SAFETY EVALUATION BY THE OFFICE OF NUCLEAR REACTOR REGULATION  
RELATED TO AMENDMENT NO. \_\_\_\_\_ TO FACILITY OPERATING LICENSE NO. DPR-28  
ENTERGY NUCLEAR VERMONT YANKEE, LLC  
AND ENTERGY NUCLEAR OPERATIONS, INC.  
VERMONT YANKEE NUCLEAR POWER STATION  
DOCKET NO. 50-271

# DRAFT

Revision 1  
November 2, 2005

Figure 2.8.7-25  
Comparison of TBGLA-6 and CASMO-4 Pu-239 Composition for Lattice 6996

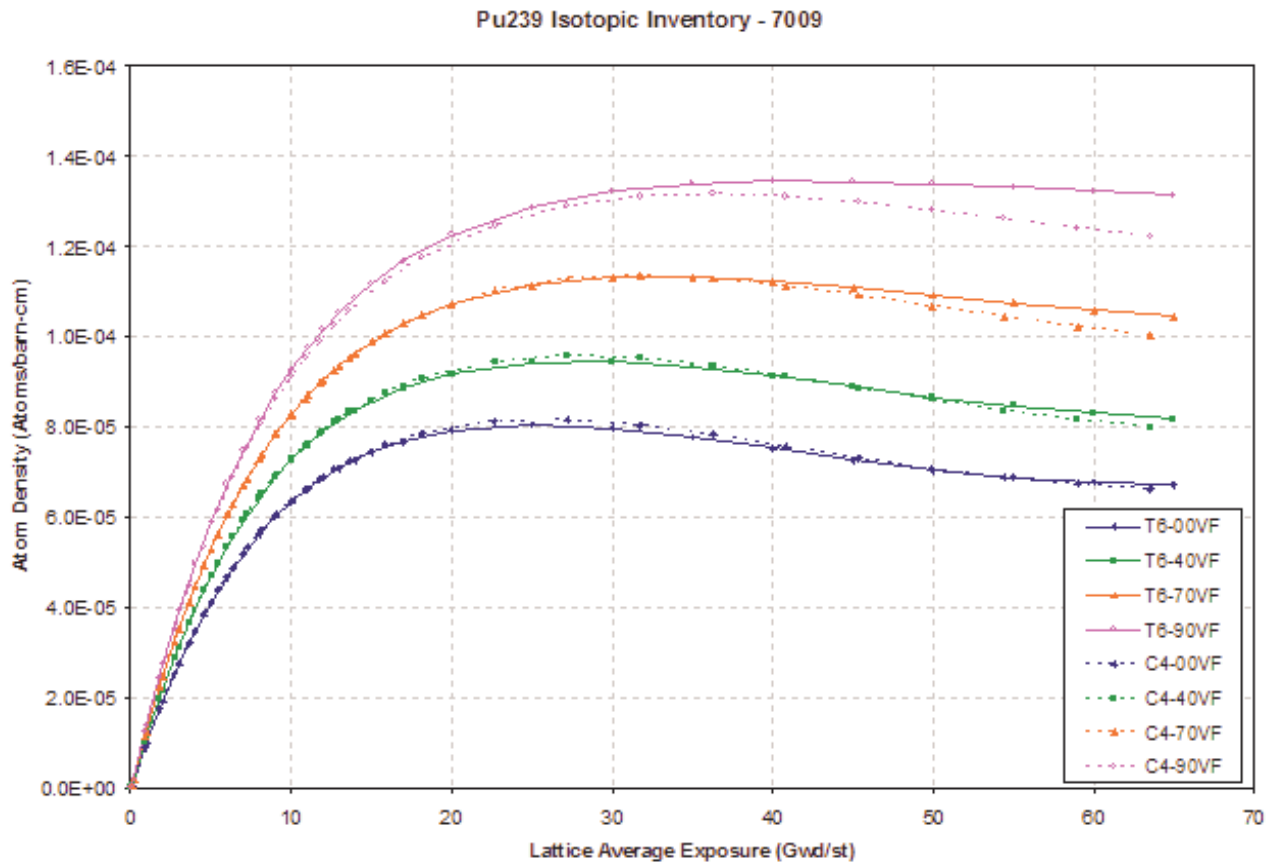
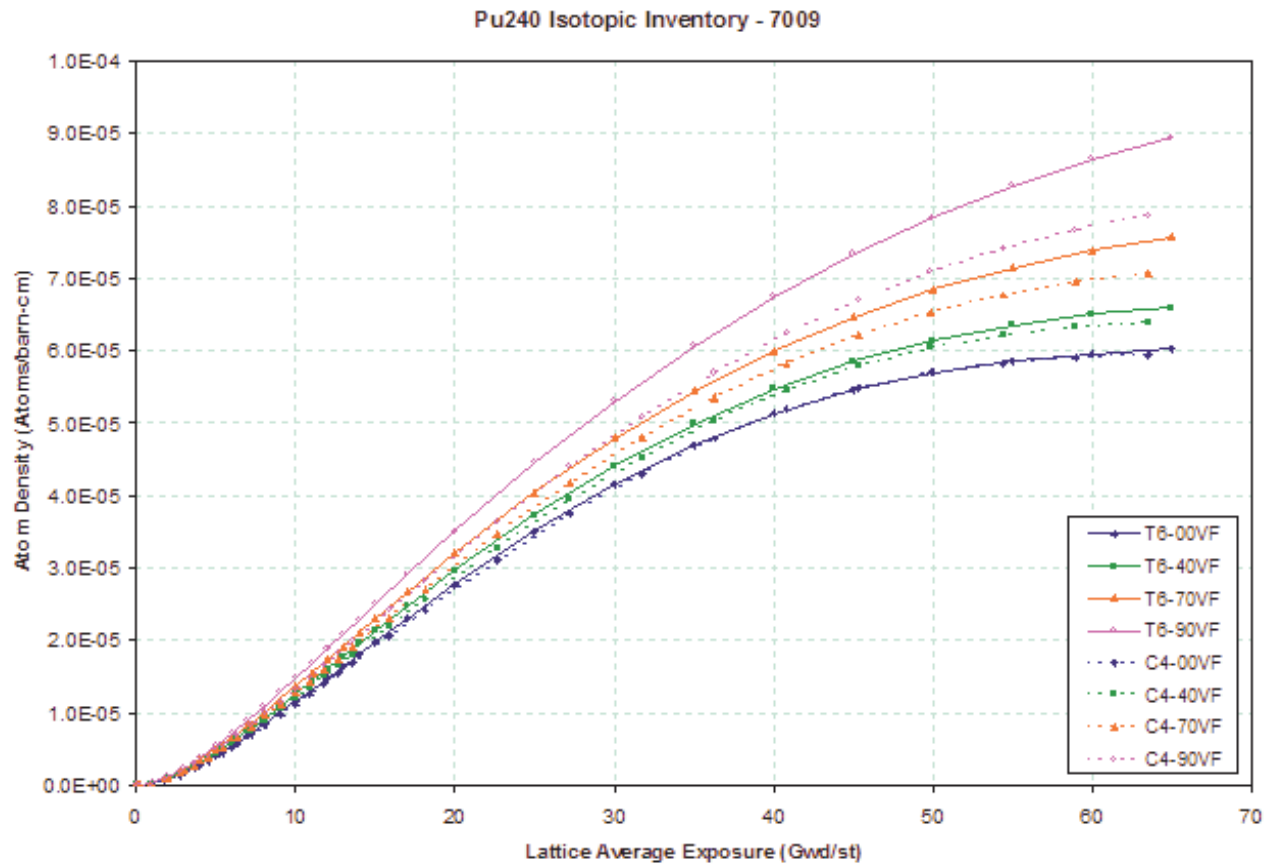
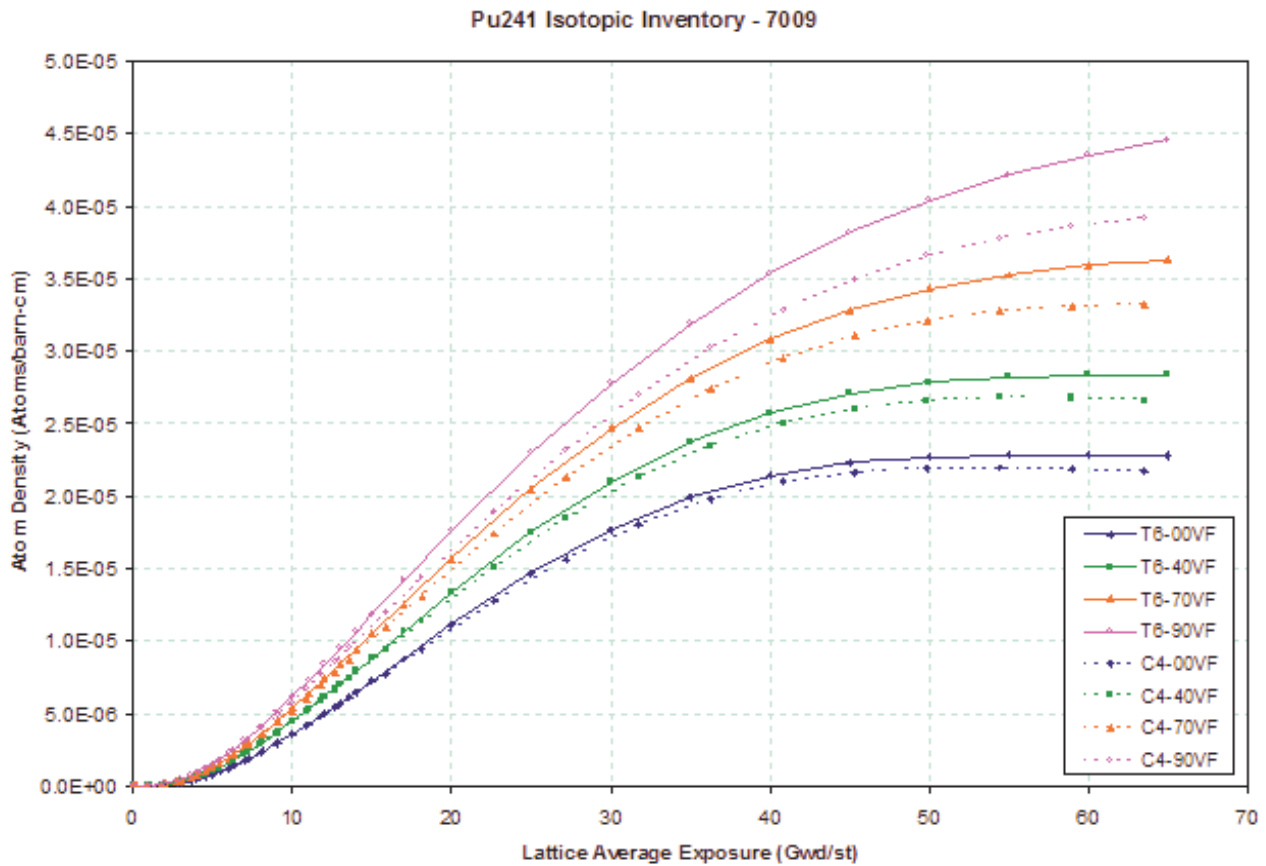
The plutonium compositions were compared between the two codes as indication of the prediction of the neutron spectrum and as a further investigation of potential impacts the void reactivity coefficient and SDM. The comparison of the Pu-239, Pu-240 and Pu-241 isotopic compositions (Figures 2.8.7-25 to 27) show very good agreement, particularly at the lower void fractions. Notably, Pu-239, the primary fissile plutonium species present, has very close agreement between the two codes.

Figure 2.8.7-28  
Change in Pin Power Distribution Between 0% and 30% Bypass and Water Rod Voiding

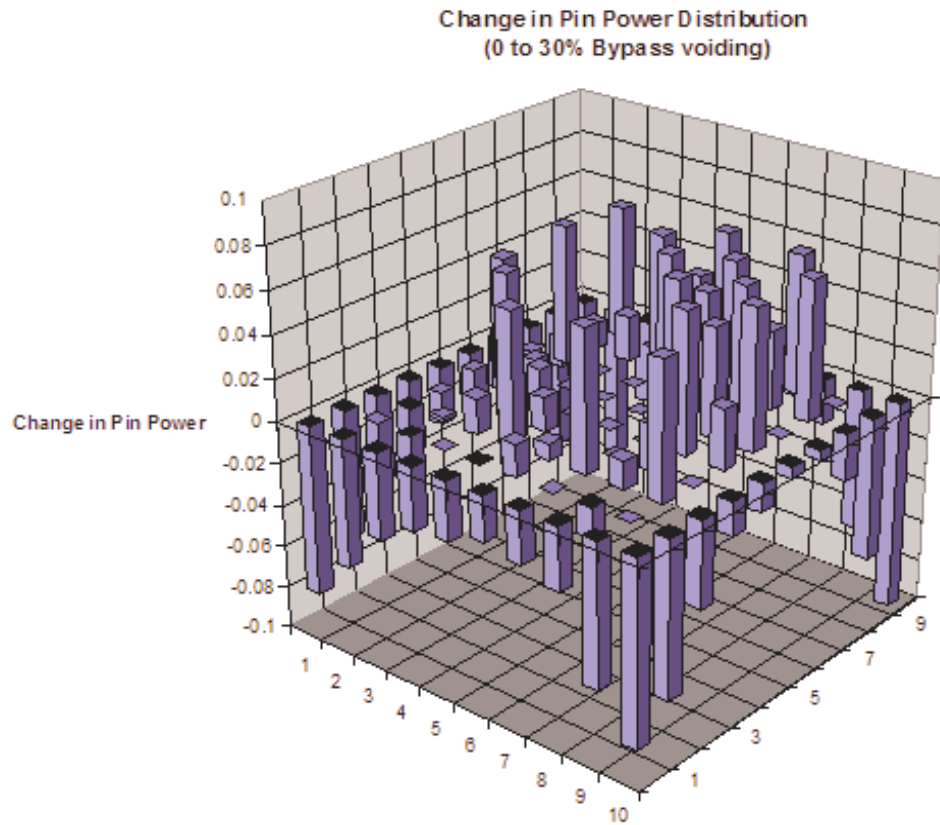
The results indicate that the power generation in the bundle is shifted away from the bypass region to the interior region of the bundle as voiding occurs. This is clearly demonstrated by plotting a difference of the power distribution between the 0% and 30% voiding cases, as is shown in Figure 2.8.7-28. The largest reduction in the pin power occurs in the corner pins, which have to faces adjacent to the bypass region. This results in a reduction of the power peaking factor since the peak pin is located near the bypass region. The reduction in the RMS of the pin power difference from the unity results presented in Table 2.8.7-3 show that the power profile becomes more uniform (“flatter”) as the bypass region voids (an RMS of zero would indicate a flat power profile, while a large value indicates a high-degree of peaking). The results also show that the relative power of the peak pin also decreases (the peak does remain in the same pin for all bypass void conditions). The reduction in the lattice Kinf value indicates that the overall bundle power will also decrease as the bypass region voids, as also indicated by the GE analysis.
